UNITED STATES OF AMERICA
NUCLEAR REGULATORY COMMISSION
ATOMIC SAFETY AND LICENSING BOARD

In the Matter of
AMERGEN ENERGY COMPANY, LLC
(License Renewal for Oyster Creek Nuclear
Generating Station)

Docket No. 50-0219-LR
ASLBP No. 06-844-01-LR
October 29, 2008

(Addressing The Issue Referred By The Commission Regarding The Adequacy
Of AmerGen's Proposed 3-D Finite Element Structural Analysis Studies)

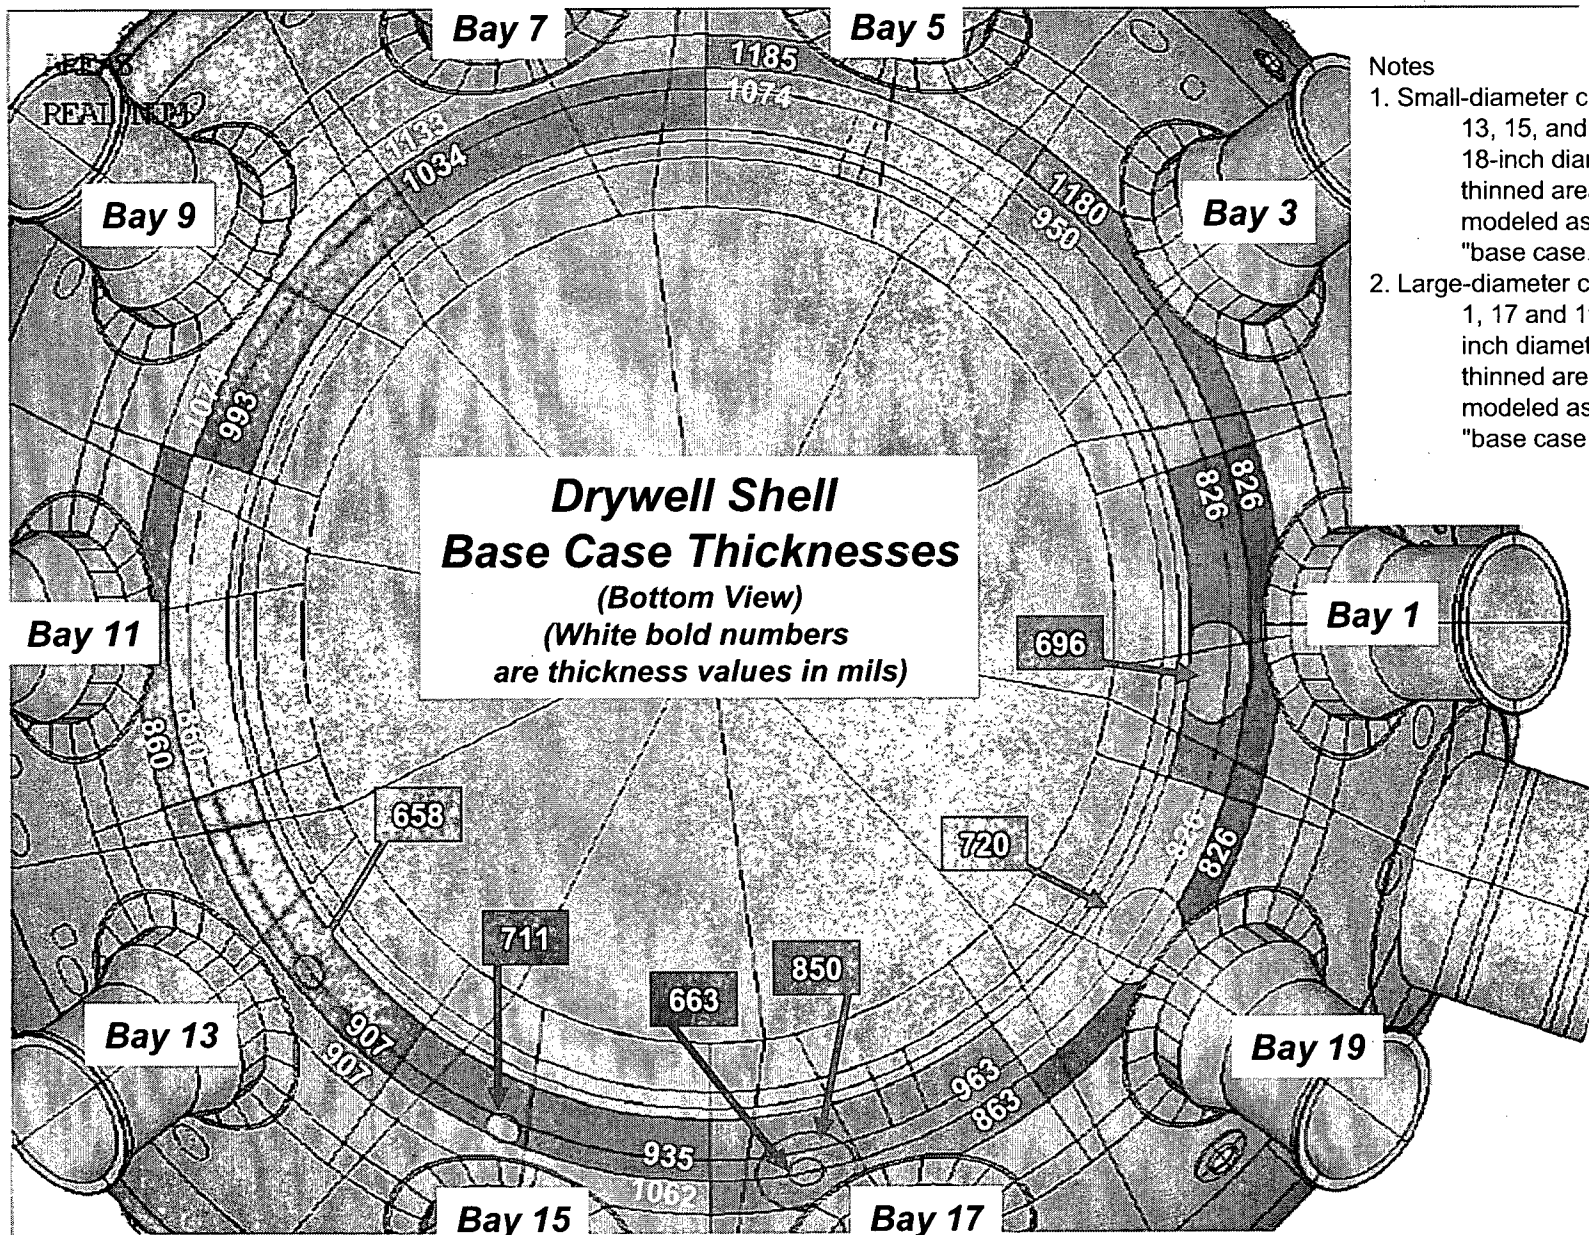
1. We believe that Citizens’ comment concerning the size of the regions in the model is consistent with good engineering practice and has sufficient merit to warrant further action by AmerGen in its development of a conservative best estimate model of the drywell shell. Some of the bays exhibit regions that show little or no corrosion, yet these are modeled as thinned regions in the proposed AmerGen model. For example, visual observation in Bay 1 determined that there are areas approaching original thickness that are adjacent to thinned areas. See Tr. at 940-41 (Polonsky). While this may seem conservative, it may or may not be depending on how the thicknesses of these regions were used. Because there are visual observations of the corrosion, it should be possible to estimate the size of these regions and – informed by engineering judgment – to further subdivide the model where warranted to account for them. We believe this should be done to better capture the true margin.

3. It is unclear as to how AmerGen factored into the averaging process UT data that show near-original thickness in development of the average thicknesses used for bays that have heavily corroded areas. We suggest that a sensitivity study be performed to assess the impact of any outlier data on the averages used in the model as outlier data might cause the averages to be biased thick or even thin.

4. The proposed general area reduction of 0.050 inch in the lower half of Bay 19 does not appear to encompass the uncertainty introduced when the external points are compared with the thicknesses proposed by AmerGen in its second sensitivity study. To evaluate the sensitivity of the results, we suggest the reduction in thickness should be increased to 0.075 inch. This value is about equal to the average value of the differences between AmerGen's proposed lower area model input averages and the lower area measured data averages as calculated by Citizens for all ten bays. See Hausler October 1, 2008 Affidavit tbl. 1 (indicating the average value of the differences in the lower area (last column) is 0.078 inch).

5. We recommend that AmerGen not limit the second sensitivity study to just one bay, Bay 19. Rather, AmerGen should also look at the effect of decreasing the thickness in at least one of the other corroded bays, such as Bay 1. It should then look at the combined effect of decreasing the thickness in both Bays 1 and 19 to determine what effect reducing the thickness has on the safety factor.
